**DANE COUNTY DEPT. OF  
PUBLIC WORKS, HIGHWAY &  
TRANSPORTATION**

# ADDENDUM

**RFB NO. 317020 - ADDENDUM NO. 1**

**HVAC EQUIPMENT REPLACEMENT**

Drawing Title:  
**EXTERIOR CONCRETE KNEE  
WALL PLAN, NOTES AND  
PICTURES**

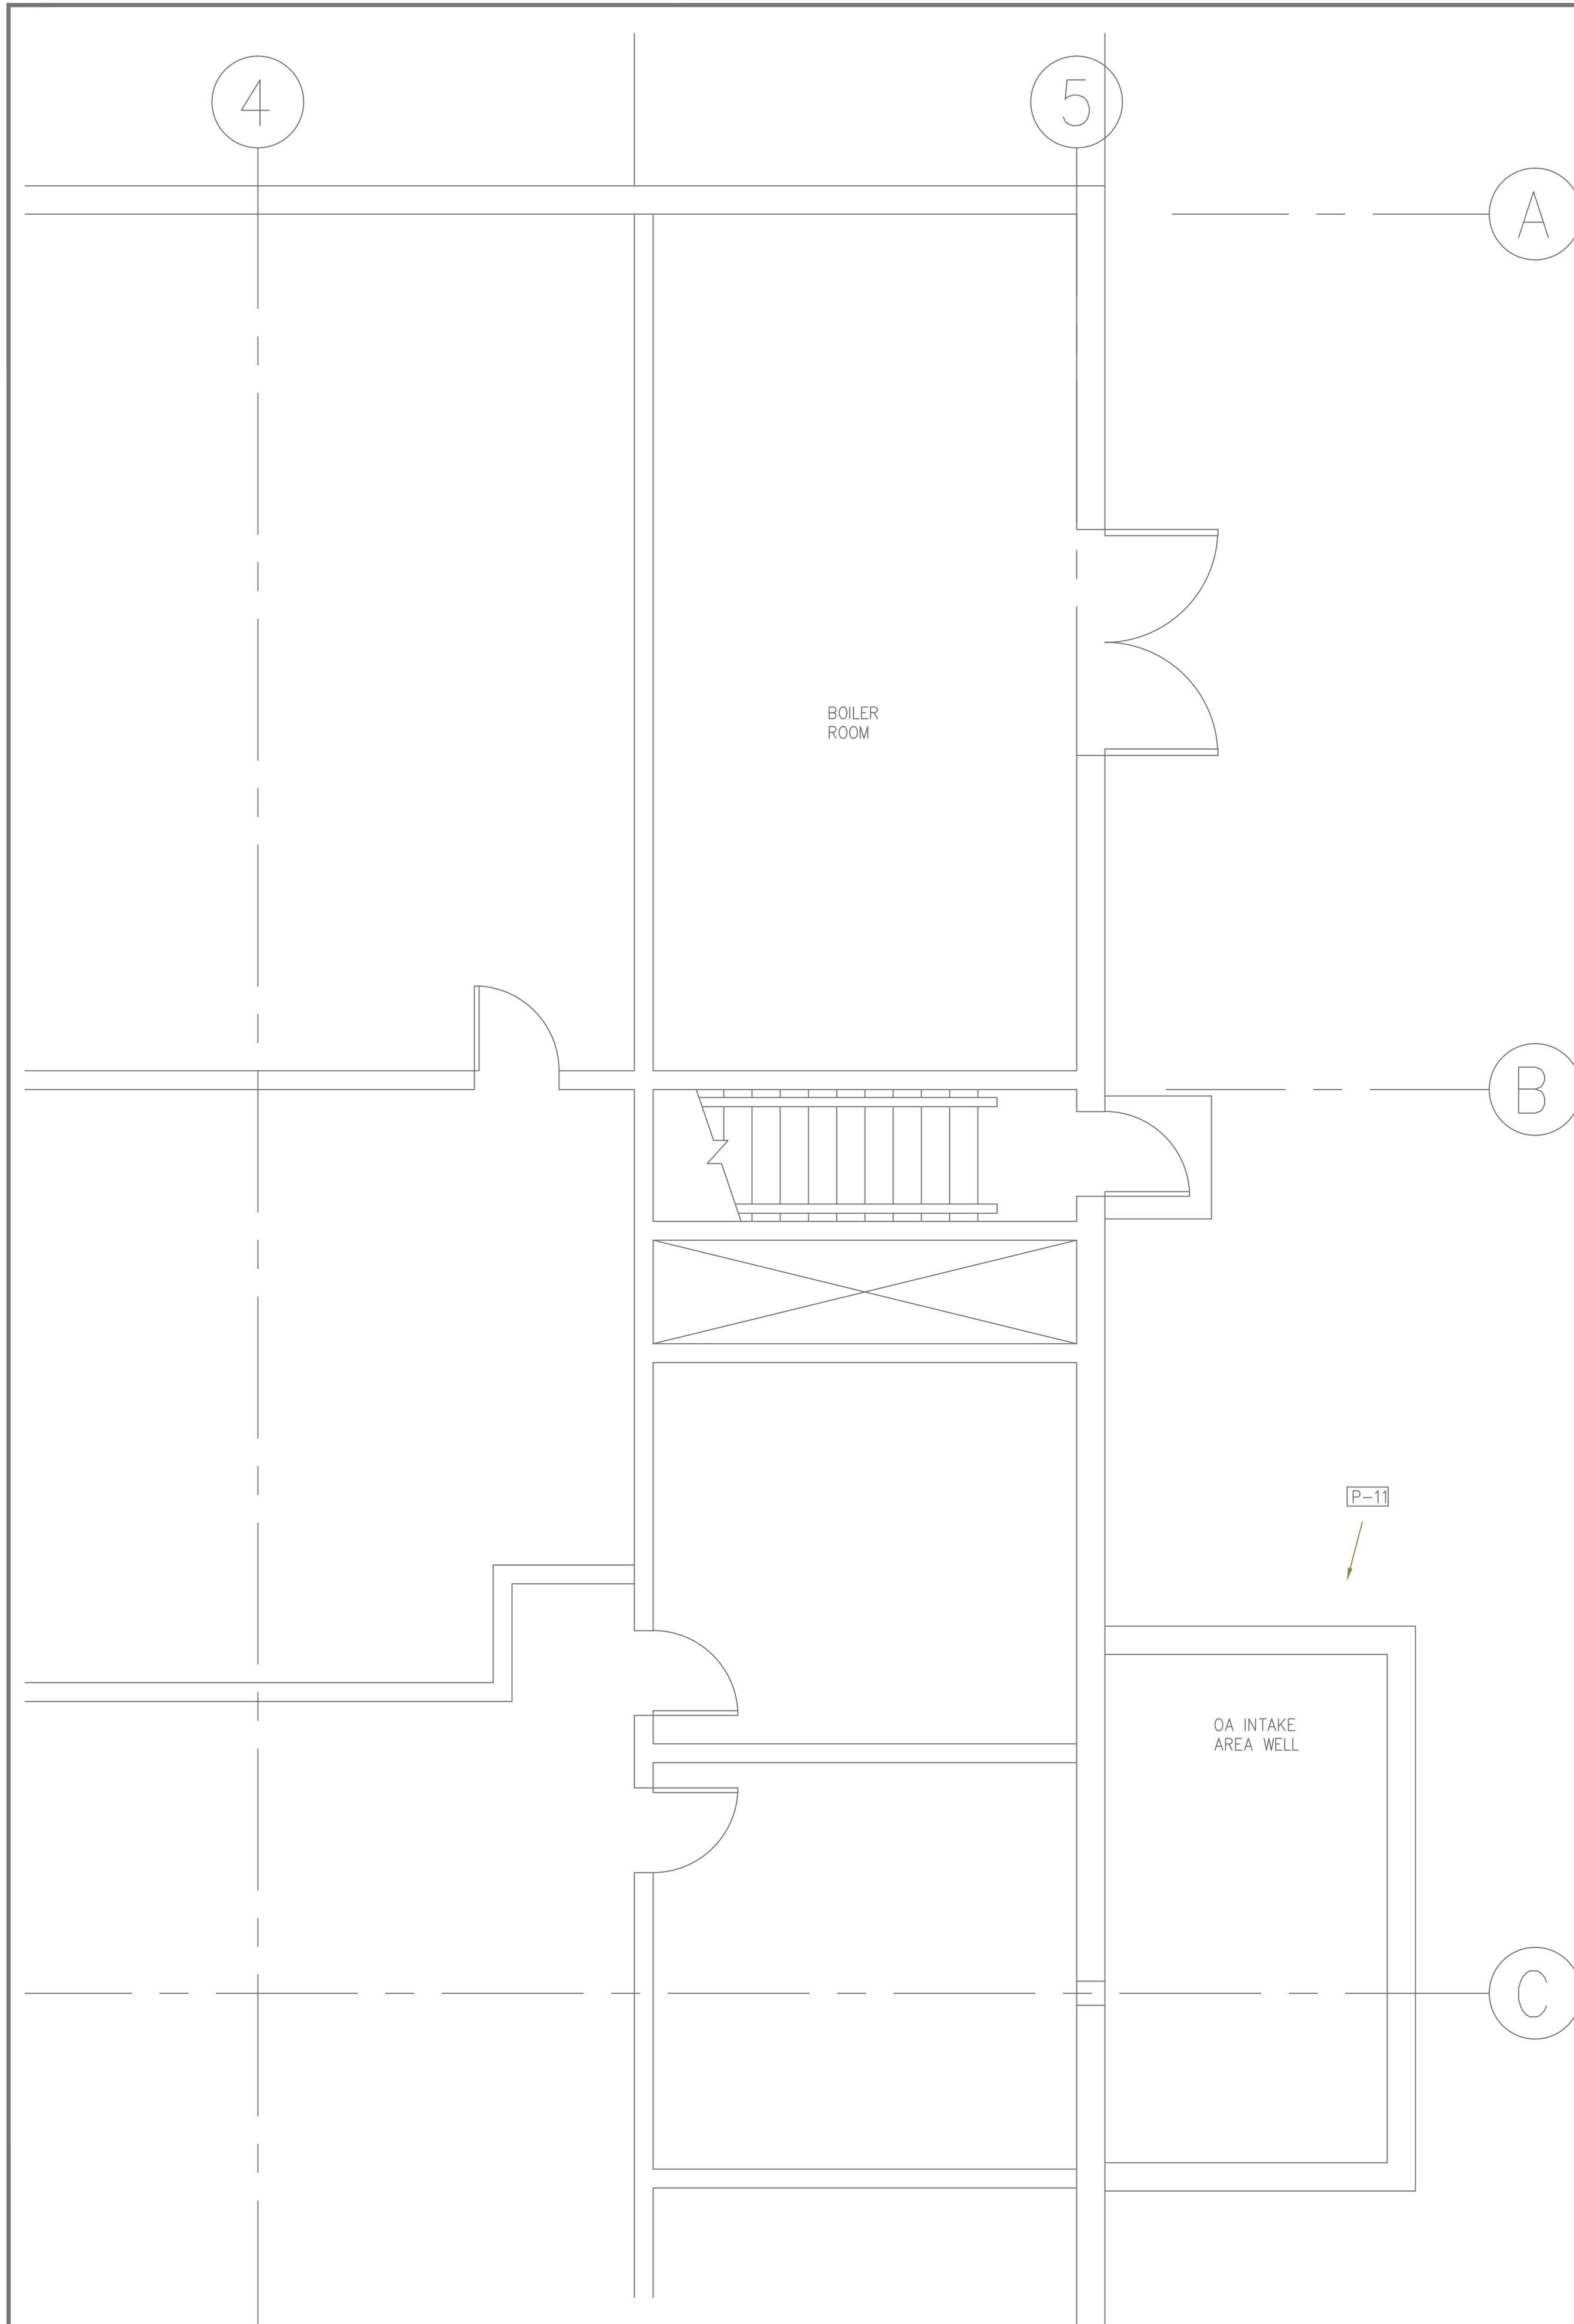
**4. Sheet C100**

Add new Sheet C100, issued with this Addendum. Plot Sheet on 24” x 36” (ARCH D) paper for correct scale or size.

**OA INTAKE AREA WELL CONCRETE KNEE WALL WORK:**

4. ROUGH UP EXISTING CONCRETE SURFACE WITH CHIPPING HAMMER TO CREATE BETTER BONDING SURFACE FOR NEW CONCRETE.
5. THOROUGHLY CLEAN EXISTING CONCRETE WITH HIGH PRESSURE SPRAYER.

6. DRILL HOLES FOR REBAR A MINIMUM OF 4" DEEP AT THE FOUR CORNERS & 2' ON CENTER ON THE THREE SIDES OF NEW KNEE WALL.
7. ANCHOR EPOXY COATED #4 REBAR INTO NEW HOLES IN EXISTING CONCRETE. REBAR SHALL GO 4" BELOW AND 16" ABOVE EXISTING CONCRETE LEVEL.

8. DO NOT PIN OR ATTACH NEW CONCRETE TO EXISTING BUILDING.
9. PROVIDE FORMS FOR NEW CONCRETE TO BE SAME WIDTH AS EXISTING CONCRETE AND 18" HIGHER THAN EXISTING.

10. PROVIDE CONCRETE WITH 3/4" AGGREGATE, 4000 PSI, 4-5" SLUMP.
11. CONCRETE TO BE COLORIZED TO MATCH BUILDING EXTERIOR; USE BASF MASTERCOLOR BURNT OCHRE (MC3510) OR APPROVED EQUAL. CONCRETE TO BE COLORIZED ACCORDING TO MANUFACTURER'S DIRECTIONS. CONTRACTOR TO SUBMIT AND OWNER TO APPROVE COLOR SAMPLE BEFORE BATCH IS MIXED & INSTALLED.
